Staff Report – Variance

Case: VAR-2025-06

Proposed Request: Variance Request variance to increase the allowed density within the *Traditional downtown core* from the required six to twelve (6-12) units to sixty (60) units, reduce the required parking from the 1.75 stalls/units to 1.6 stalls/unit, reduce the required minimum bedroom size by 150 square feet for each one, two and three bedroom type, reduce the front yard setback to 10 feet to accommodate on street parking, reduce the minimum floor-to-ceiling height on first floor from eighteen (18) feet to ten (10) feet and reduce the retail glazing to 50% of the length of the retail portion of the building to transparent glazing to 30-40% of the length of the building, for the construction of a new mixed-use development within the Downtown Mainstreet District (DM).

FOREST PARK MIXED-USE

1	PRESENTATION - SITE PLAN
2	1" = 1' SCALE

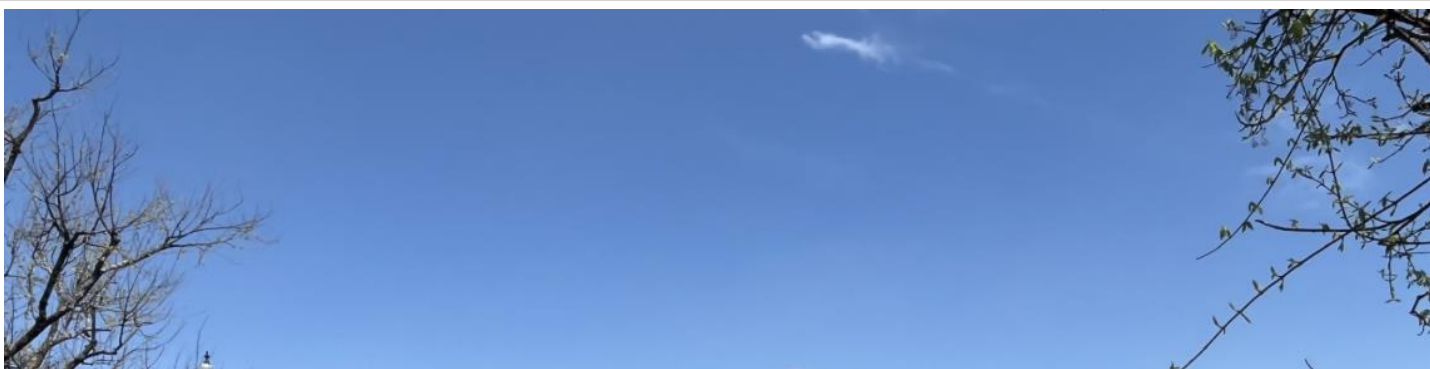
2. Staff recommends approval of the front set back to 10 feet to create on street parking so as long as parking stalls are constructed as depicted in the provided site plan.

6. Staff recommends maintaining the parking requirement of 1.75 stalls per unit. If the applicant is approved for 60 units, no parking variance will be needed, as the proposed parking is adequate with 1.75 stalls per unit. However, the applicant must obtain approval from the neighboring lot and provide staff with a parking agreement from the lot owners west of the property, confirming that the development is authorized to utilize their spaces for parking. This agreement must be submitted to staff prior to the issuance of the certificate of occupancy.
7. If the Mayor and Council approve the development of the 60 units, staff recommends that the applicant preserve the architectural design as presented in the rendered photo provided to staff.
